CRA Design Review Committee  
Held Virtually on Zoom  
Meeting Notes  
Date: September 7, 2022

## BIOGEN BUILDING 8 TANKS & ENCLOSURE AT 125 BROADWAY

## MXD EAST WEST CONNECTOR PLAY AREA

BIOGEN BUILDING 8 - TANKS & ENCLOSURE  
 FIGURE 3: PROPOSED SITE PLAN & SECTION

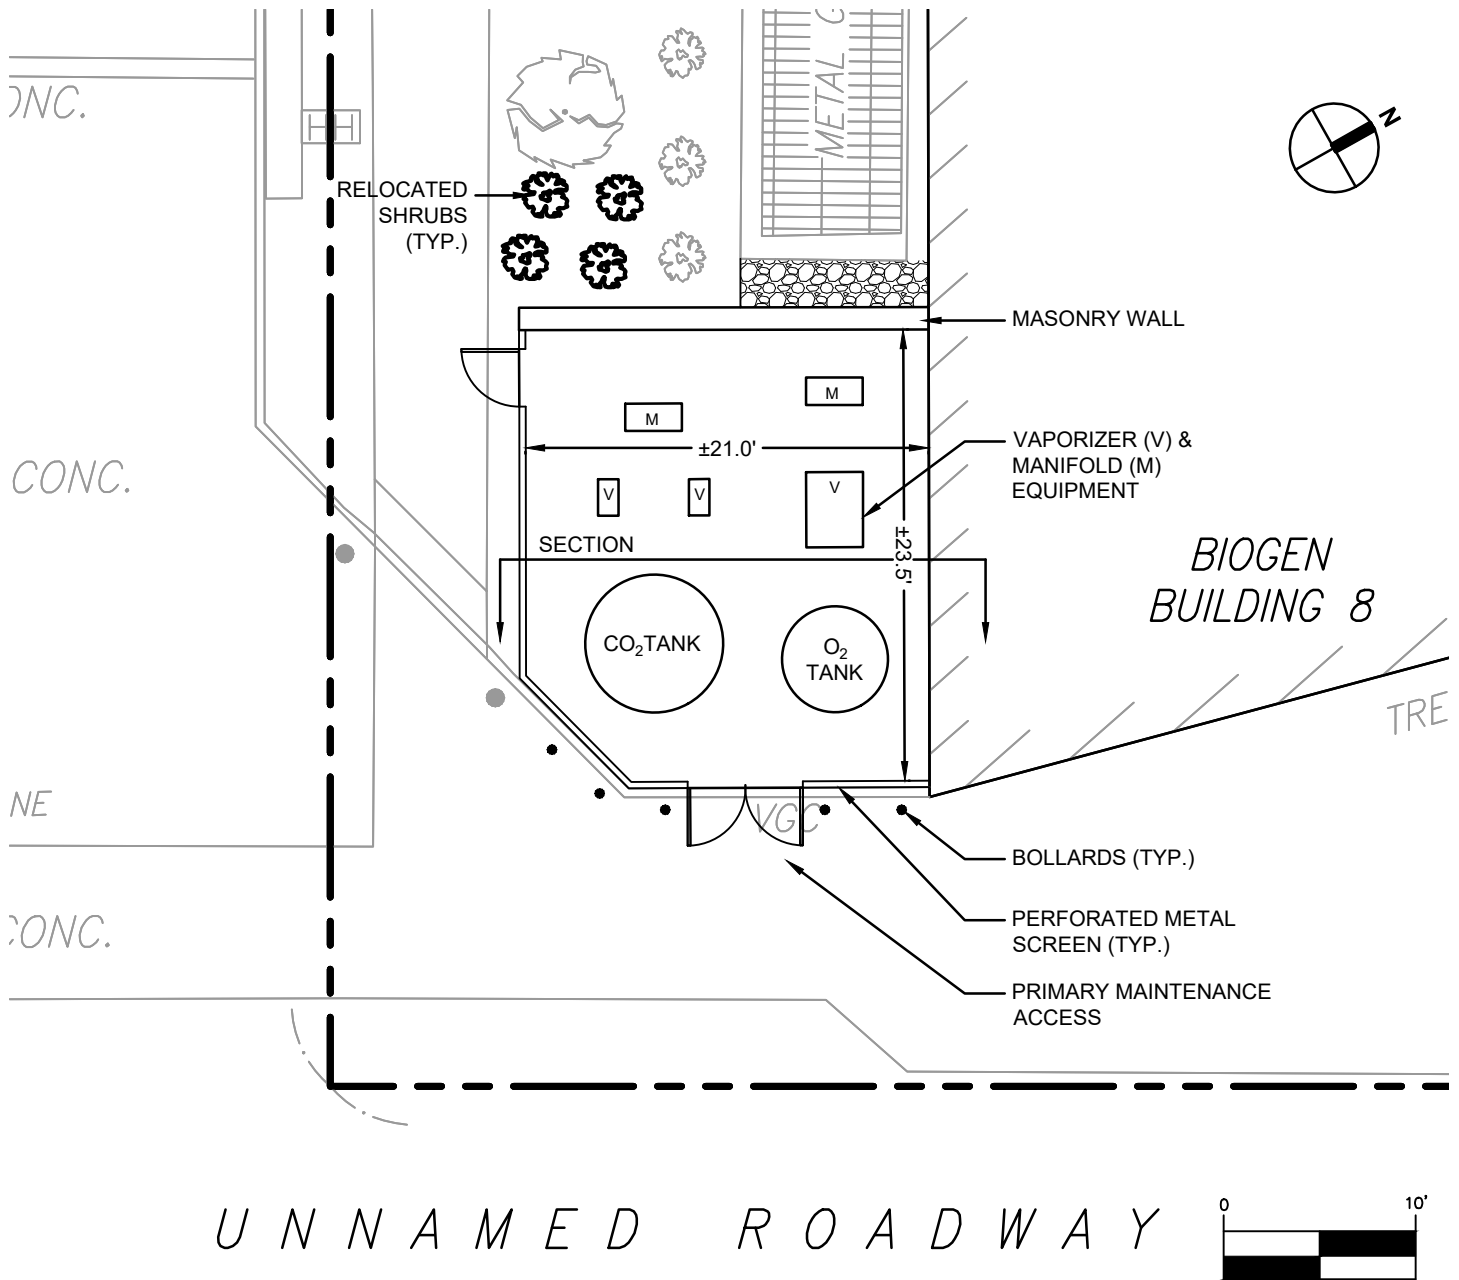
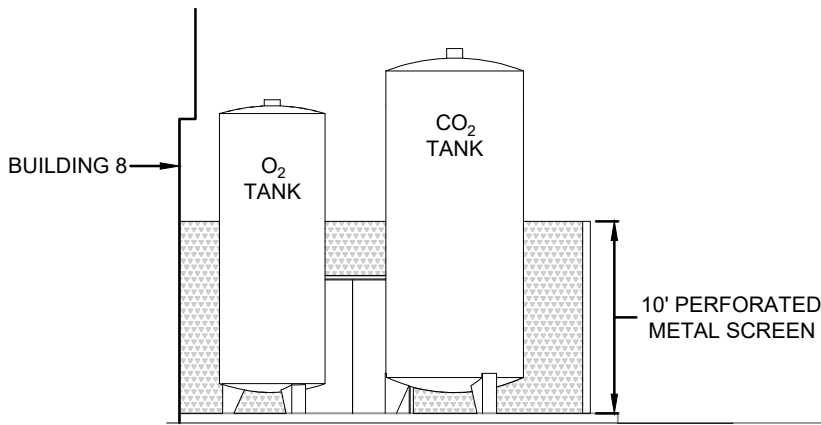
Mr. Zevin asked if there was a sidewalk in front of the tanks. Ms. Prestileo noted there was a 10ft pedestrian pathway in front of the tank. Mr. Zevin also asked why the installation of the fire-rated wall did not address exposure to the louvers at the side of the loading dock. Mr. Watts answered that they meet the building setback requirement set by Airgas and NFPA, and what was driving the firewall position was a relief fan that blocks the horizontal louvers inside the loading dock that operates during emergency conditions. Mr. Zevin also shared that it is important to keep the east-west connector views transparent and visible, and he was concerned about the brick wall coming up to the edge of the pedestrian path. He suggested cutting the masonry wall short and making the secondary door side diagonal. Mr. Watts said it was possible to cut the wall short. Mr. Zevin asked how far they had to extend the protection from the louvered wall.

Mr. Zevin recommends a guardrail along the roadway to avoid trucks backing into the bollards at an angle. Mr. Evans wondered if more density of bollards might be helpful.

Ms. Bigolin asked if the CO2 tank could be moved behind the oxygen tank for less visual impact. She also wondered if the blue bubble screen wall could reflect vegetation to blend in with the area's greenery by having the wall be the same color as the existing vegetation or include vegetation on the screen wall like vines. Biogen team answered that the blue was selected to match the blue garage, which could be changed since the garage will be demolished, and will look into redesigning the graphics and color of the wall. Ms. Prestileo noted that they are thinking about the rearrangement of the tanks. Ms. Bigolin asked if the screen wall could be lowered to address Mr. Zevin's comment. Mr. Zevin agreed that reducing the screen wall height would be favorable. He further proposed that screening the tanks from view is neither necessary or desirable; similar installations are secured by relatively transparent fencing at MIT and elsewhere. He also agreed with Ms. Bigolin's suggestion to align the tanks along the building rather than perpendicular to it. Ms. Prestileo said they would look into graphics and opportunities to include the suggestions.

SMMA team asked if the priority for the area is mitigation of wind through the corridor, which would make the screen wall beneficial, or is it visual access through the corridor? Mr. Evans answered that visual access through the corridor was the priority for the area. Biogen team asked if the trees should be replaced and, if so, what type of species to introduce. Mr. Evans noted that replacing the trees is more important than the type of species it is. They also asked if there is a recommendation for bollard spacing. Mr. Evans noted that the bollards need to be denser when whatever it protects is closer. Mr. Zevin said the bollards are too close and are doing nothing. Mr. Evans recommended maintaining the bollards in its current location but moving the fence back.

# SITE PLAN - PAVING PATTERN WATER MOTIF

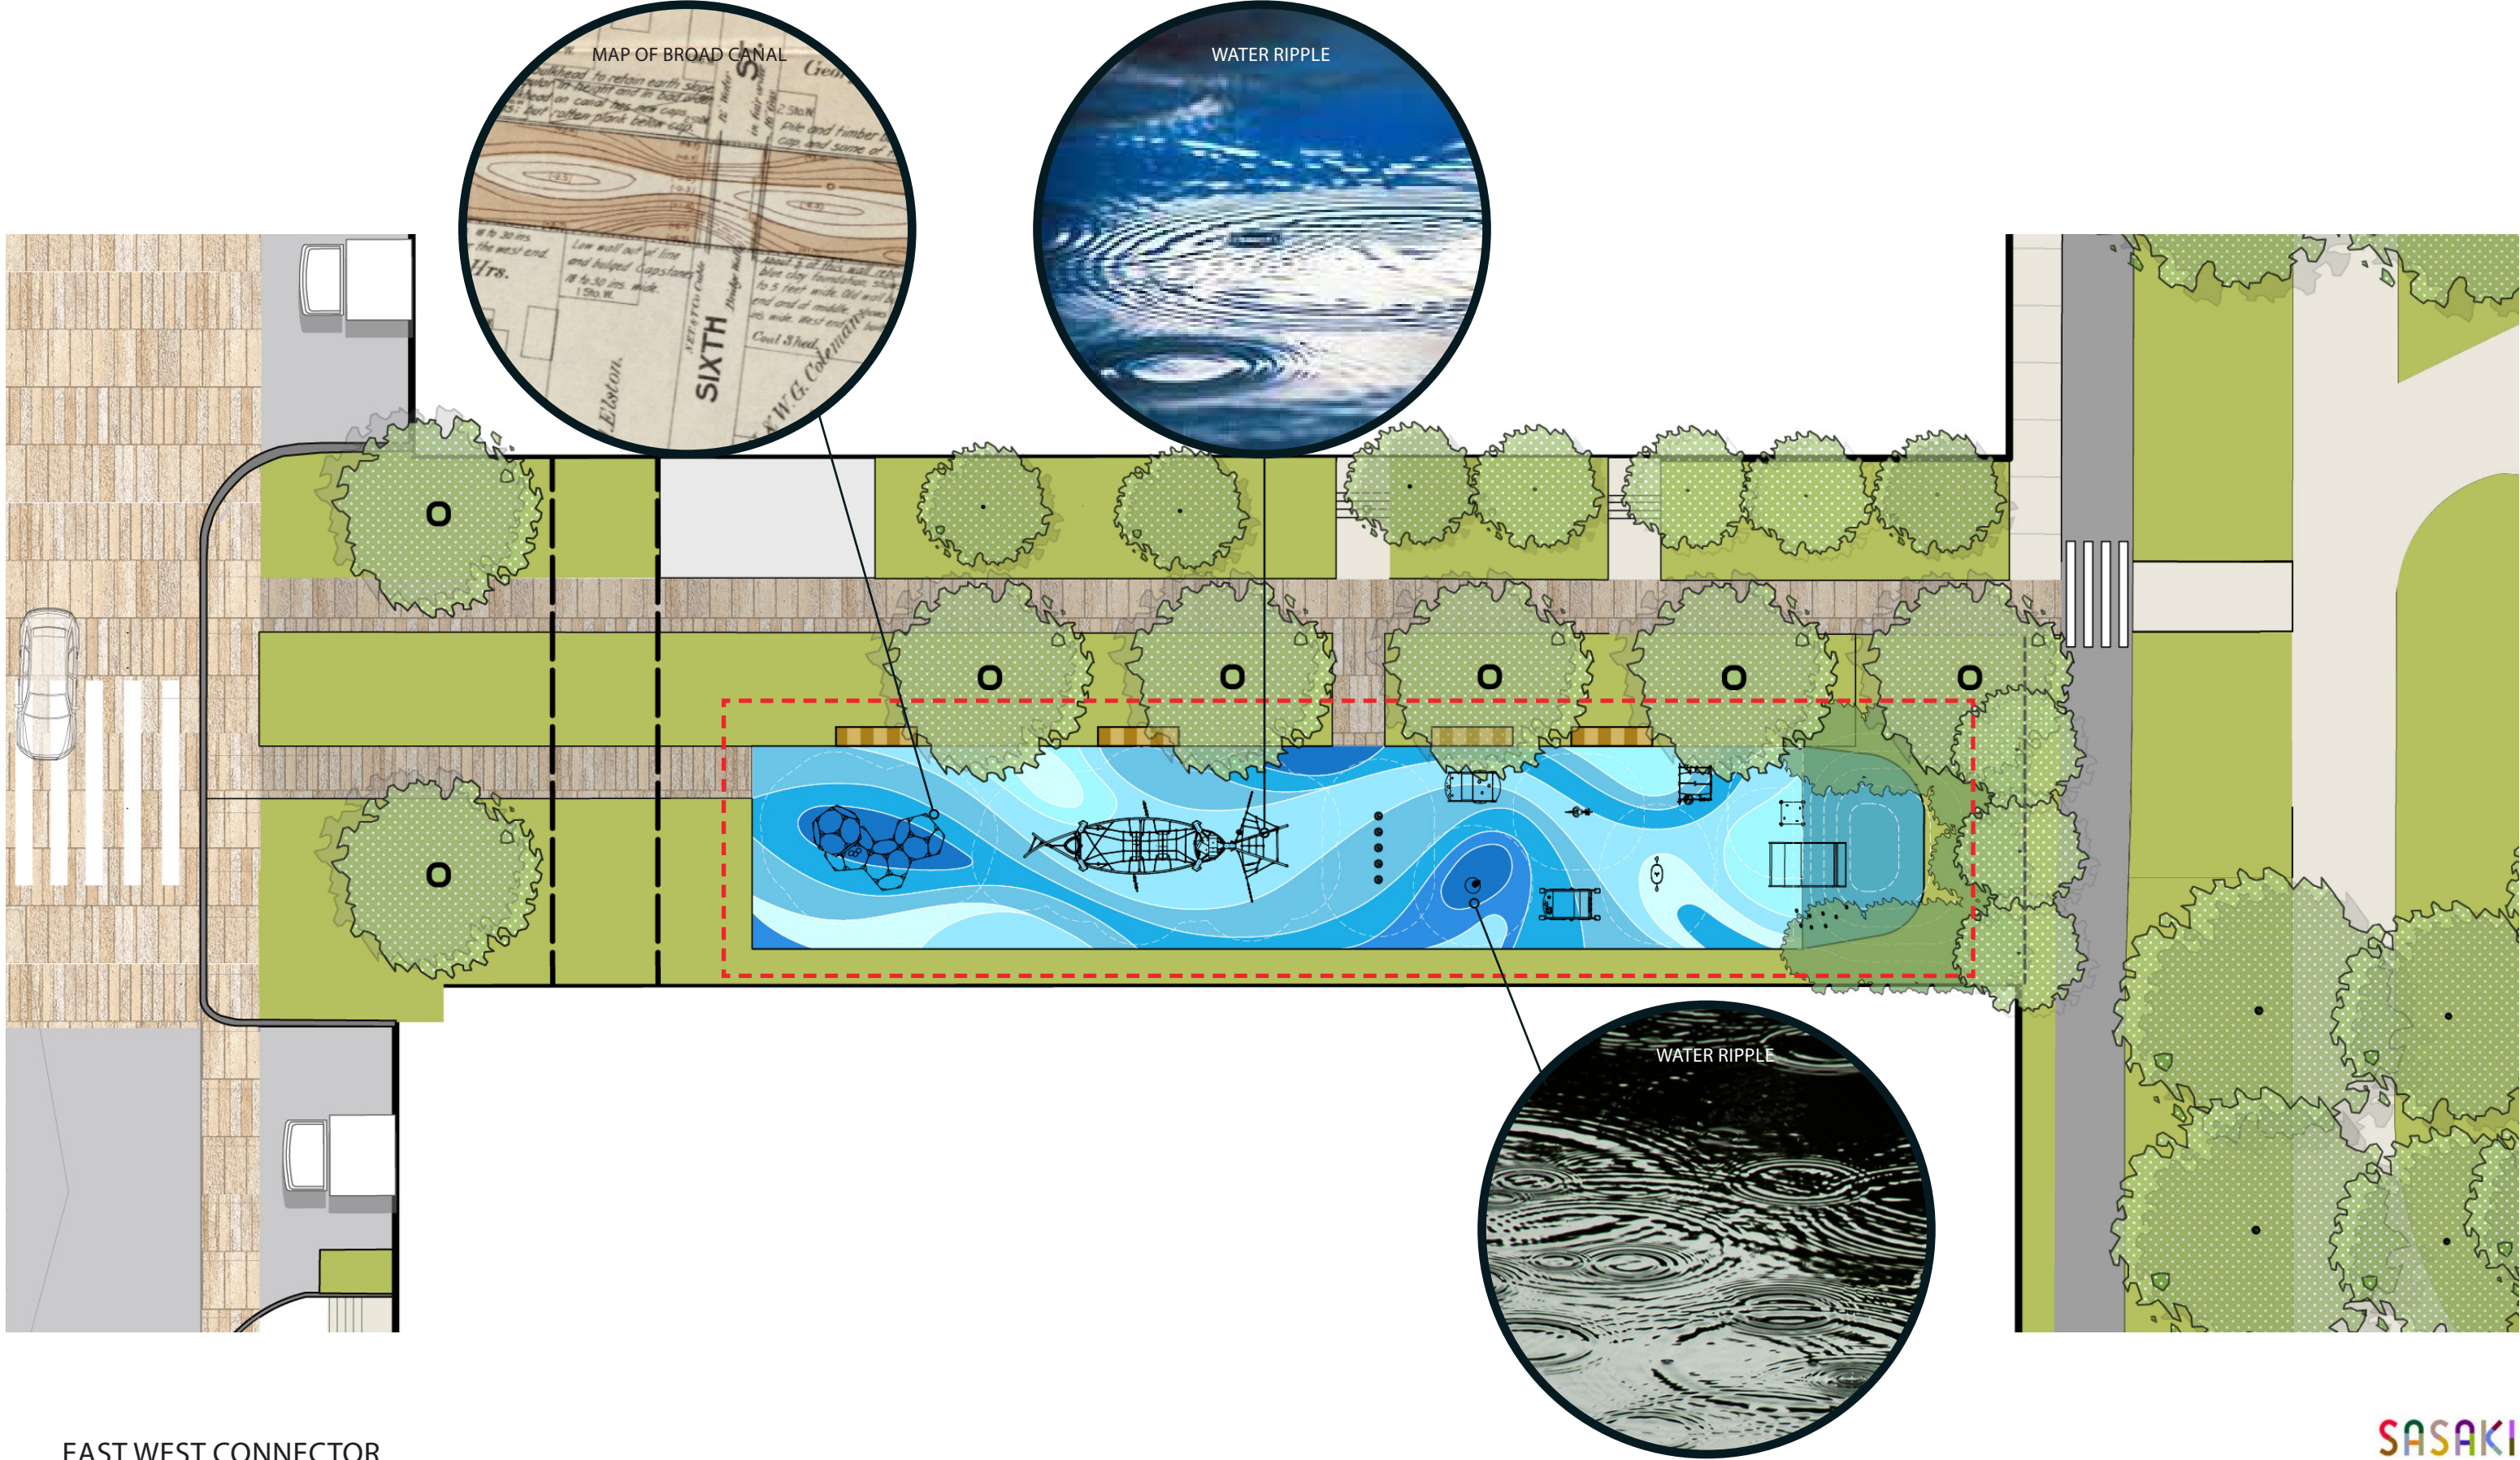
Mr. Zevin liked the design and said the only feature he would reconsider is the grass on the west end between the two walkways. He asked if the green space could be consolidated with the other green by eliminating the west end entrance to the park and what the designers envisioned for the space. Mr.

Mr. Evans said the trees on the park's east end might be too close to the bike path and would want to consider the impact on the roots. Mr. Smith said they would examine the trees further.

Ms. Bigolin commented that the design improved from the original vertical design. She wondered if the water motif and the green corridor could have more relationship by making the linear planting beds curvier on both sides of the space and if the planting beds could provide an opportunity for kids to go inside and explore the plantings. She thought the equipment choices were good but wondered if the slide, which will be utilized mainly by older kids, was in a good location by the toddlers' area. She suggested having the slide against the 10CC building instead of blocking the view on the east side. She also asked if the benches could be gathered to provide an opportunity for picnics in the green space between the two pathways. Mr. Smith said he liked the idea of carrying the water motif into the plant and will consider the planting bed design. He also noted that they examined putting the slide against

Smith said they conceptualized the middle green space for planting. He also noted that the second path to the park was considered from a safety standpoint to provide two forms of entry into the children's play area. Mr. Smith said they could think of another north - south connection. Mr. Lowenberg asked if the crosswalk on West Service Drive could shift north to align with the current path.

EMBANKMENT SLIDE EXTRA WIDE, 5 FT

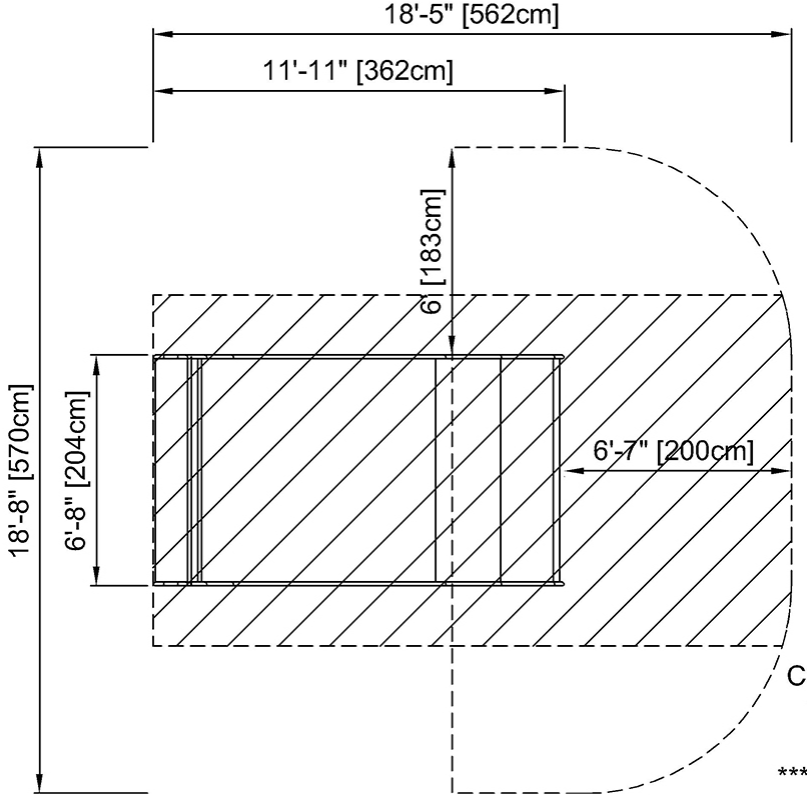
Mr. Crawford shared that he appreciated the activation of the space and the updated design. He liked that the trees are maintained and wants to continue to think about the space as a connection to the Volpe site and other open spaces in East Cambridge. He suggested having a taller slide, more challenging features, and something a little more precarious seeming but not precarious acting. Mr.

Crawford also suggested updating the existing bollards with new lighting and making the space easy to maintain. He also said the benches look welcoming and to avoid anything that makes them hard to use, like bars in the middle. Mr. Smith noted that they selected the size of the slide to prevent impact on the trees.

10CC, but it was too compressed and that he saw the slide as an option for all ages. Additionally, they see the slide as a buffer for preventing kids from running into the 6th Street connector and onto the bike path. Mr. Lowenberg said the slide was about 4 feet high and was geared toward the younger crowd.
